energy center

Sufficiency Responses

From: Barbara_P_Linkiewicz@fpl.com
Sent: Tuesday, June 07, 2005 5:12 PM
To: Kosky, Ken
Cc: Rachel_Godino@fpl.com; John_Gnecco@fpl.com
Subject: West County Energy Center - DEP SED comments

AERIAL PHOTOGRAPH

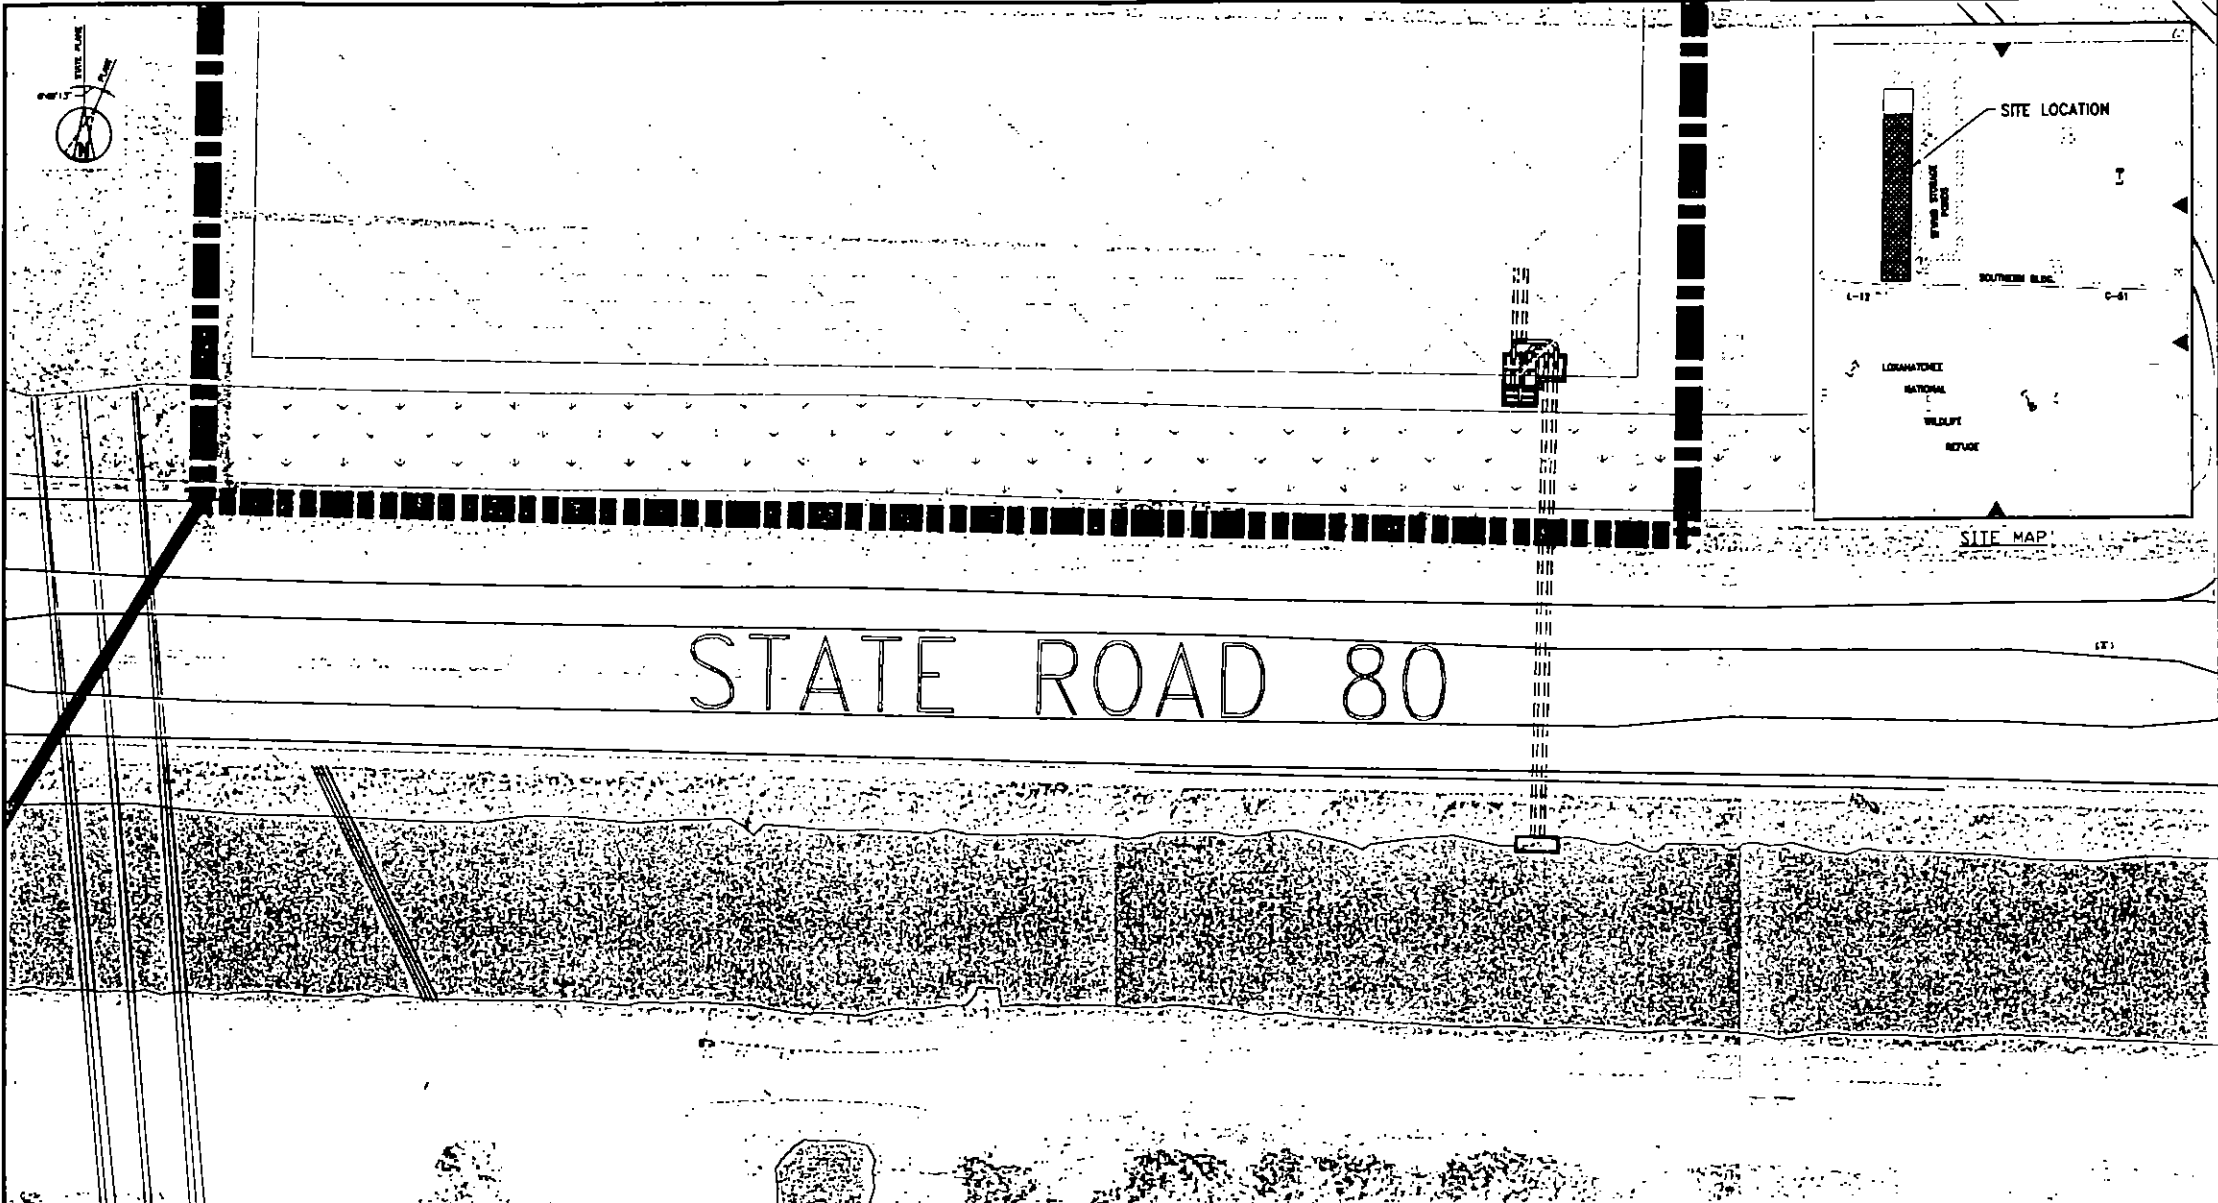
- (1) The sketches provided need to be supported with recent aerial photography of the proposed site. SFWMD-1
- (2) The drawings must show the SFWMD right-of-way lines on both the plan and profile view. SFWMD-2

PLAN VIEW ALTERNATE INLET STRUCTURE

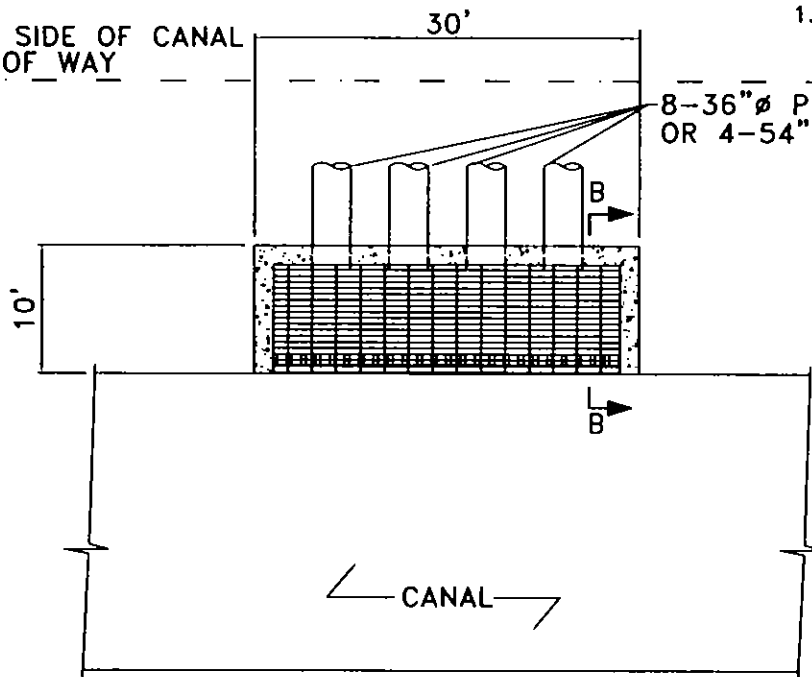
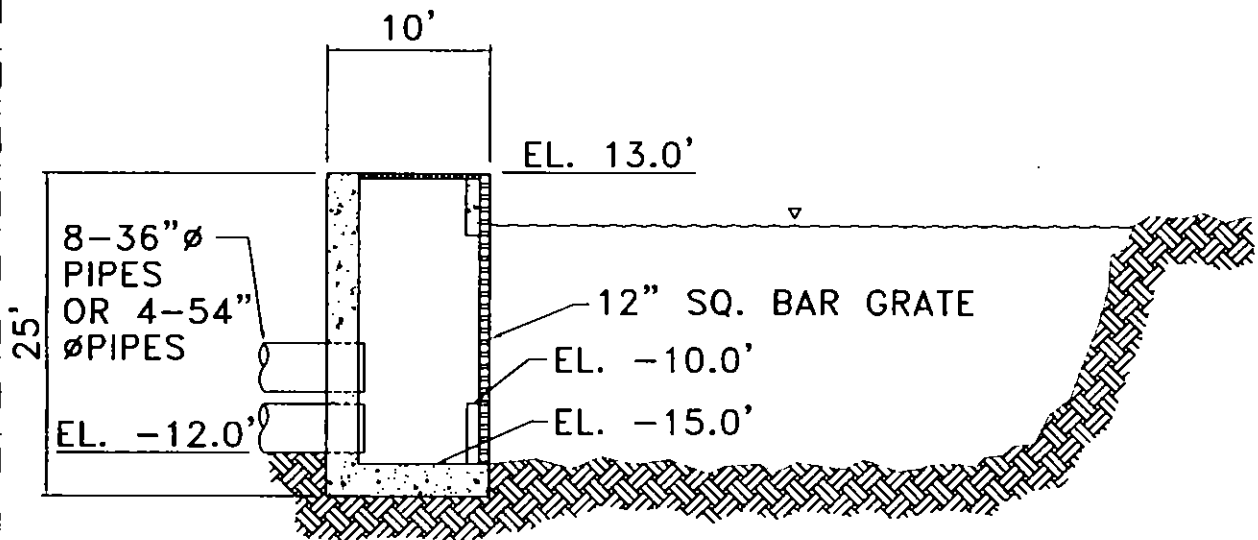
SFWMD staff cannot support the proposed location of the water pipeline intake structure on the south side of the L-10/L-12 Canal, as illustrated in Figure 3.5.0-1, as it imposes an unnecessary burden on the SFWMD for which an alternative is readily available. In addition, the proposed design shown in Figure 3.5.0-1 is contrary to the SFWMD's Basis of Review, as set forth in Volume V, Criteria Manual for Use of Works of the District (Rule 40E-6, F.A.C.). However, SFWMD staff does support the alternative location/design, as illustrated in Figure 3.5.0-2, on the north side of the L-10/L-12 Canal, which is simpler and less intrusive. Comments applicable to both Figures 3.5.0-1 and 3.5.0-2 are listed below, followed by comments that specifically pertain to each of the two figures.

- (3) The proposed design must employ rip-rap or alternative erosion control measures on canal side-slopes acceptable to the SFWMD. SFWMD-3
- (4) Any temporary construction related activities or techniques need to be covered in the proposal as well as a sequence of work, a time schedule, and an analysis of headloss in the channel due to constrictions imposed by temporary structures (particularly if sheet piling or coffer dams extending into the channel are proposed). SFWMD-4

Response 5: The intake option shown in Figure 3.5.0-1 will not be used and the information requested will no longer apply.

UPDATED SCA FIGURES 3.5.0-3

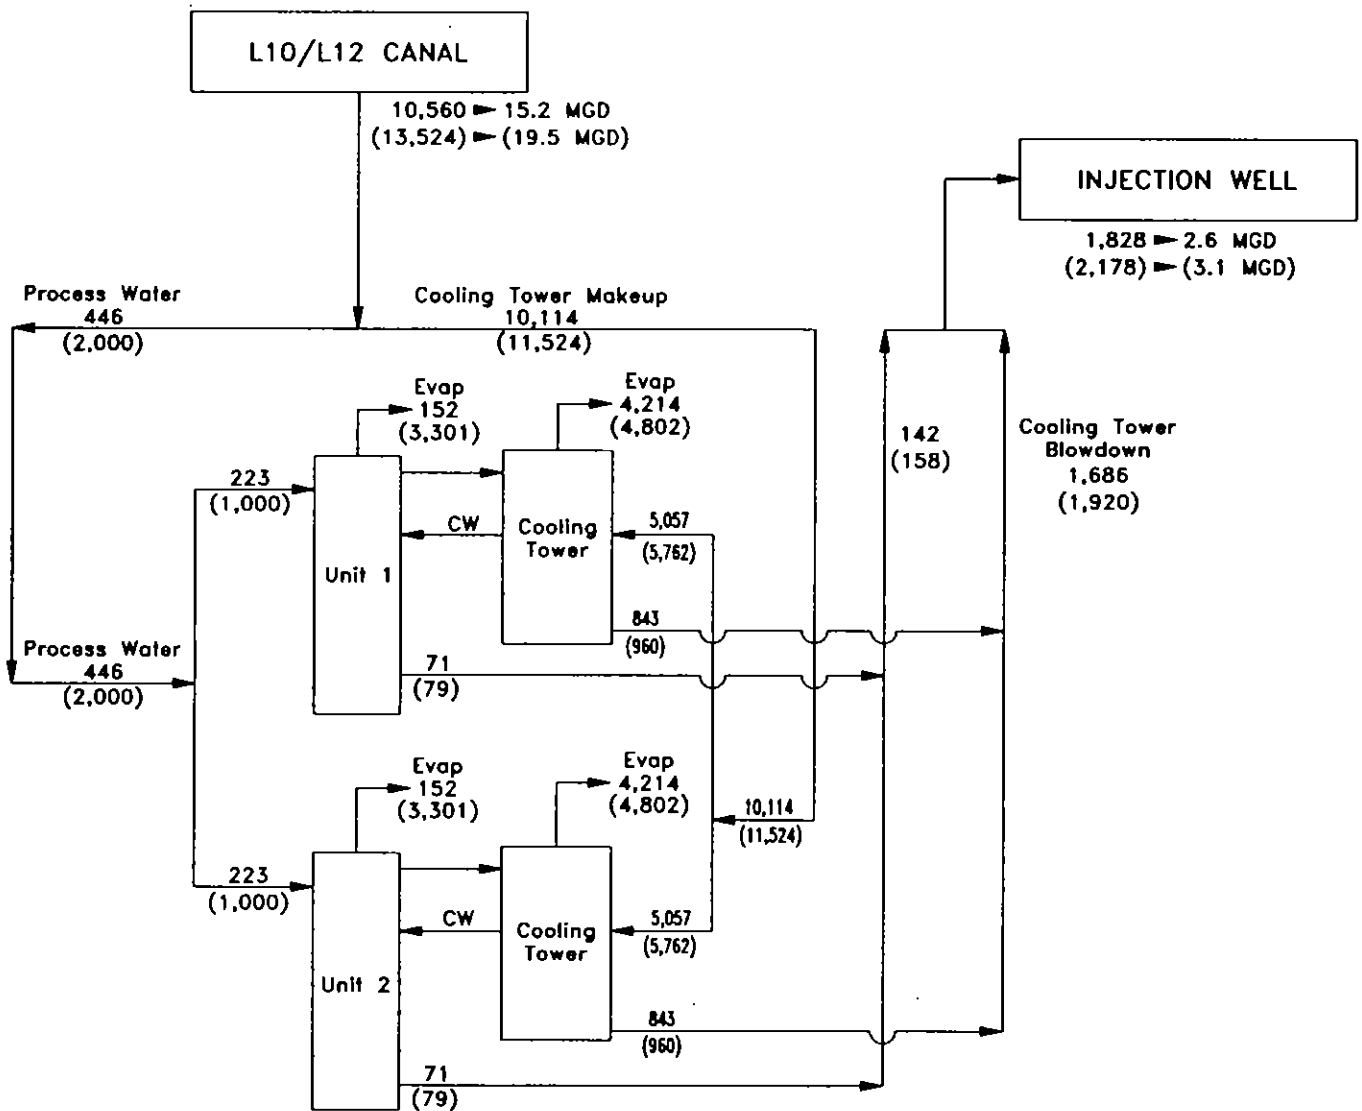
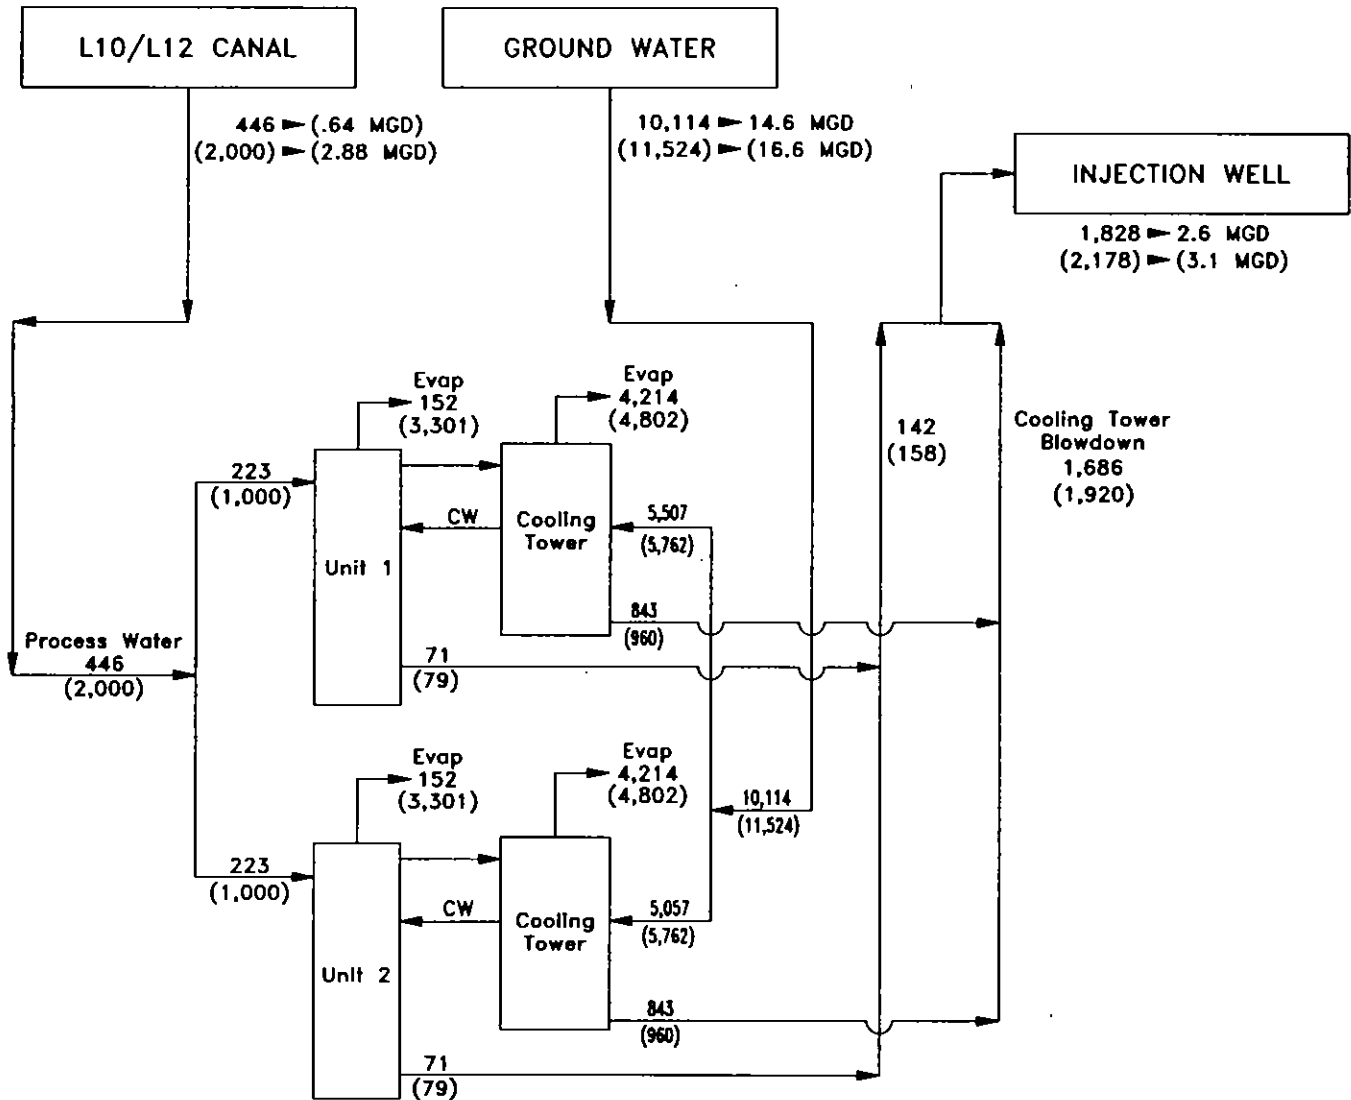
- (17) In Section 3.0 of the SCA, the demand from the L-10/L-12 canal for the cooling towers and process water is shown on the water mass balance chart as 15.20 million gallons per day (MGD) with the maximum demand as 19.5 MGD. When water from the Upper Floridan Aquifer (UFA) is used as an emergency supply, the total average demand is 15.24 MGD and the maximum demand is 19.48 MGD. Please clarify and revise, as necessary. SFWMD-17

Response 17: The difference between the numbers is due to truncation/round off when converting from gallons per minute (gpm) to million gallons per day (MGD). Also, note 4 in Figure 3.5.0-4 should read "Flows are based on 6 cycles of concentration in CT." Replacement pages for these figures are included as Attachment SFWMD-17.

WEST COUNTY ENERGY CENTER FIGURE 6

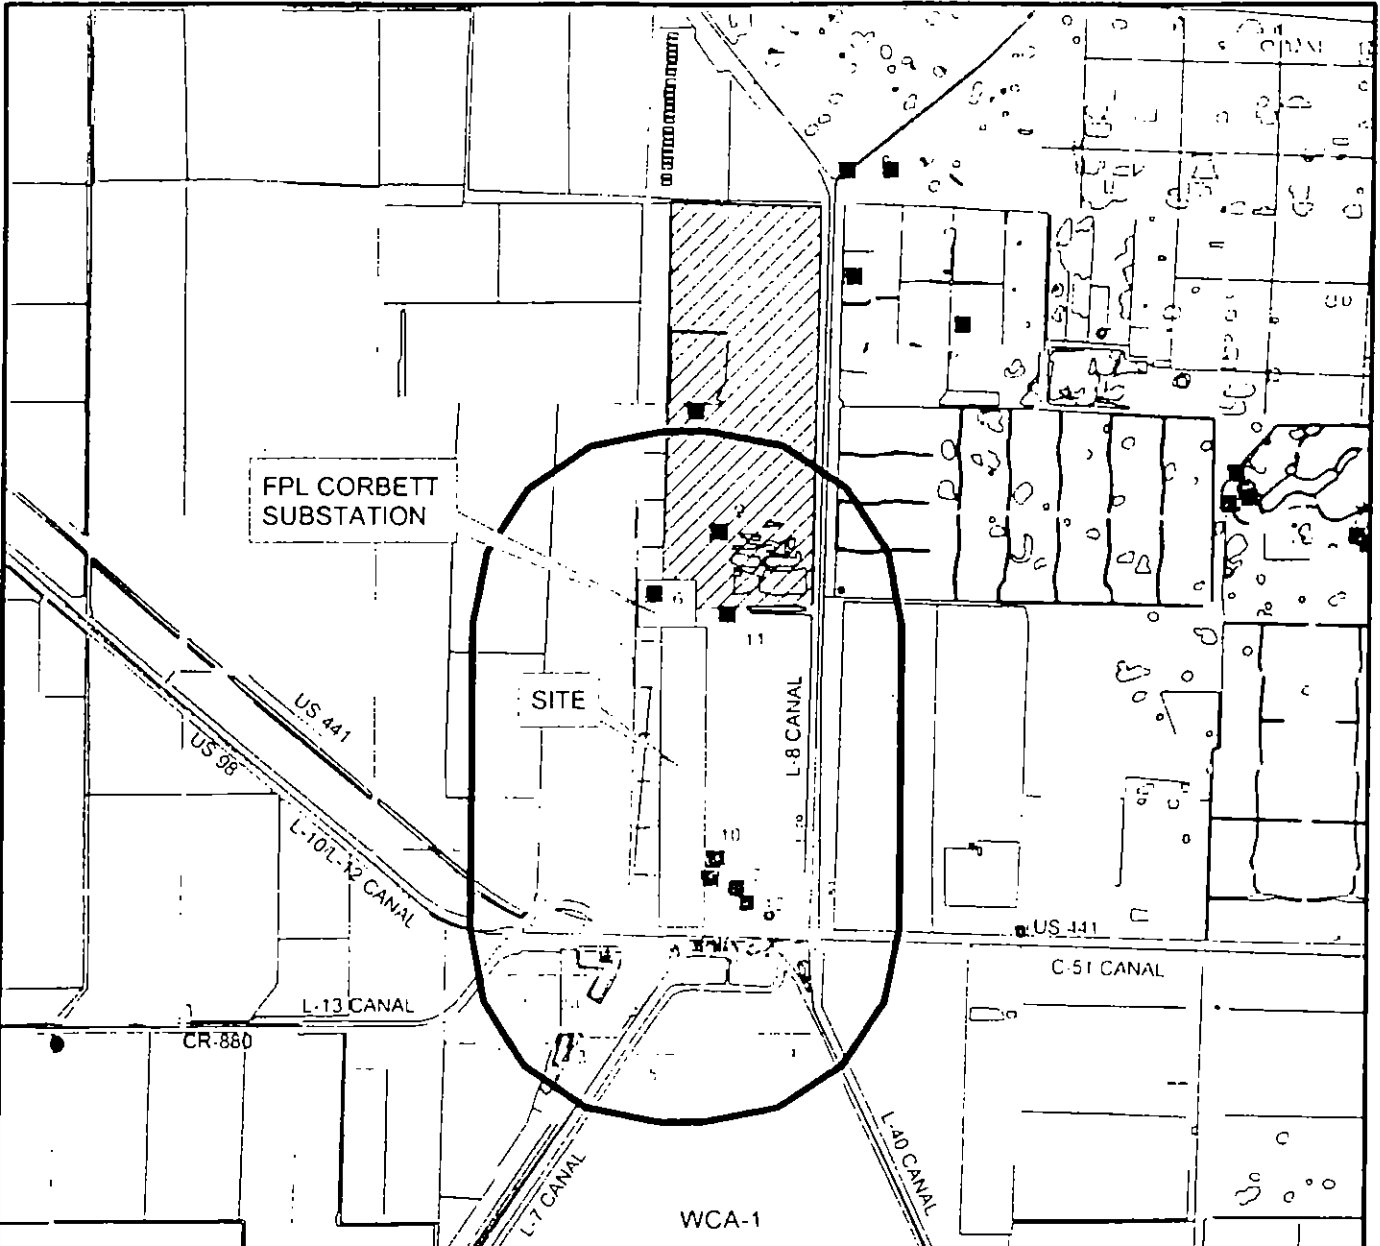
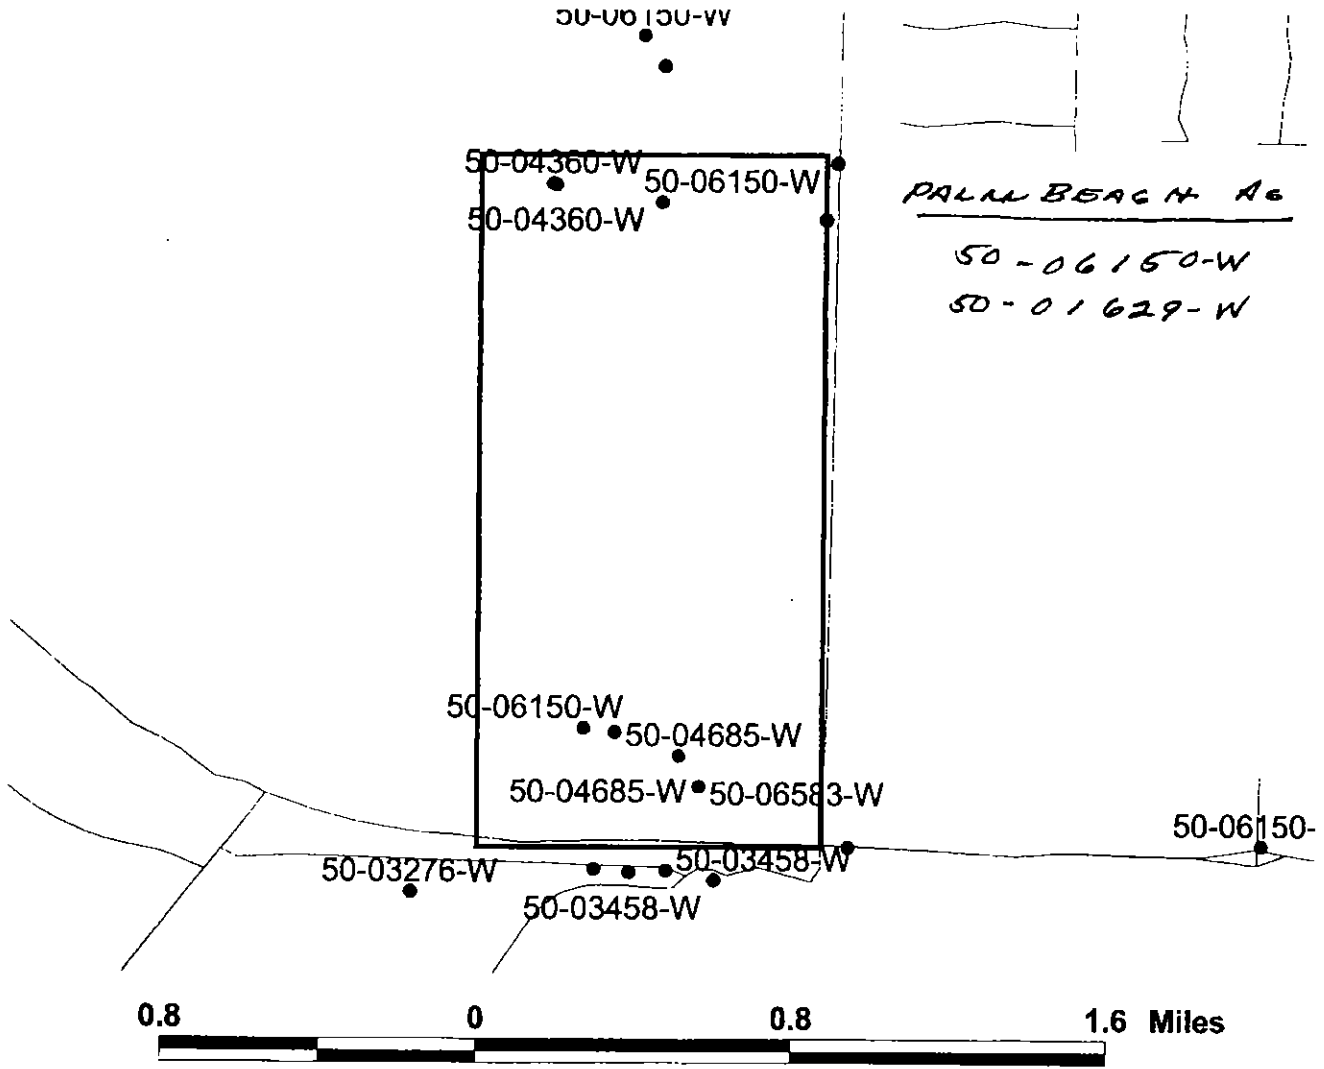
- (20) In Section 2.0 of the SCA, potable water supply wells are shown on Figure 2.3.3-1. In Appendix 10.1.8, Figure 6 shows the location of other Surficial Aquifer Wells. Other wells that do exist, some of which are located on adjacent Palm Beach Aggregates property, are not shown and were not included in the modeling. Please submit revised modeling that includes these wells. SFWMD-20

SFWMD Comment 20: In Section 2.0 of the SCA, potable water supply wells are shown on Figure 2.3.3-1. In Appendix 10.1.8, Figure 6 shows the location of other Surficial Aquifer Wells. Other wells that do exist, some of which are located on adjacent Palm Beach Aggregates property, are not shown and were not included in the modeling. Please submit revised modeling that includes these wells.

Response 20: The well information shown in Figure 2.3.3-1 of the SCA, while labeled potable water supply wells, included all wells obtained from the SFWMD's DBHYDRO database. These wells are used primarily for monitoring; the figure title should not have referred to potable wells. Table 2.3.3-2 in the SCA provides a listing of all water use permits within 5 miles of the Site including wells located on Palm Beach Aggregates property. The information in this table was obtained from the SFWMD, and it includes all water use designations and all water sources (surface water and groundwater). No existing water use permit with 5 miles of the Site designates the Upper Floridan aquifer as the source. Table 2.3.3-2 provides a location reference to the section, township, and range. Therefore, the public land survey system (PLSS) grid was included in Figure 2.3.3-1 for reference. Figure 6 in Appendix 10.1.8 of the SCA shows all surficial aquifer monitoring and supply wells within the UIC Program area of review. Figure 6 has been updated to provide reference to the well inventory contained in Table 3 of Appendix 10.1.8 of the SCA (Table 3 and the updated Figure 6 are presented in Attachment SFWMD-20). The information provided in Figure 6 and Table 3 was

Response 21: Table 3 and Figure 6 (included in the SCA) were revised to include cross references between the Figure and the Table and are included in Attachment SFWMD-20.
